DOCUMENT 009113 - ADDENDUM

- A. Project Name: Echo Electric Supply– New Lincoln Facility.
- B. Owner: QRS Investments LLC.
- C. Architect: Clark Architects Collaborative 3.
- D. Architect Project Number: 17003.
- E. Date of Addendum: 09/18/17.

- A. This Addendum includes the following attached Documents and Specification Sections:
 - 1. Document 00 00 00 Civil Table of Contents (TOC), dated 09/15/17, (reissued).
- B. This Addendum includes the attached Addendum Drawings:
 - 1. Architectural Addendum Drawing AAD-01, dated 09/15/17, revising Sheet A110.

AAD-01
09/15/17

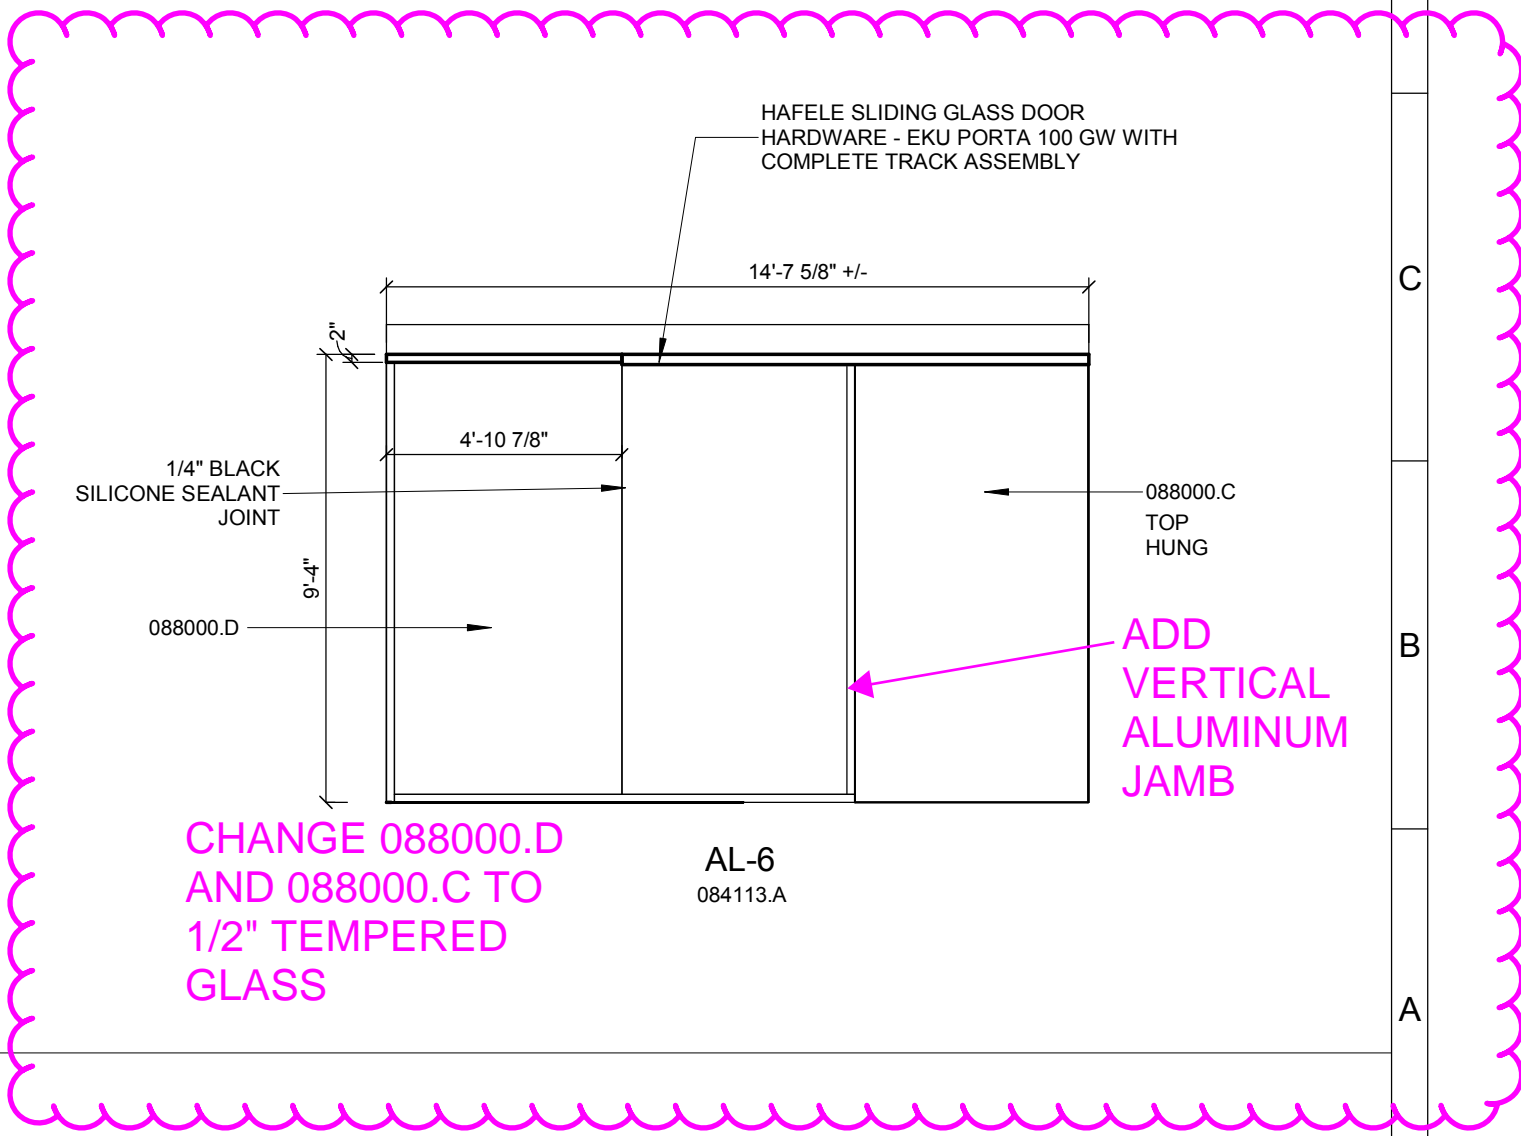
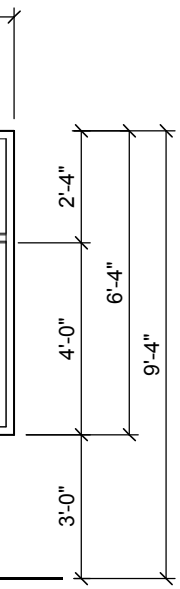
- A. Sheet A110 - Room Finish Schedule, Wall Types, Door Schedule, Door & Frame Types (not reissued).
 1. Drawing A9: Revise AL-6 in accordance with the attached drawing AAD-01 included with this addendum.

CHANGE 088000.D
AND 088000.C TO
1/2" TEMPERED
GLASS
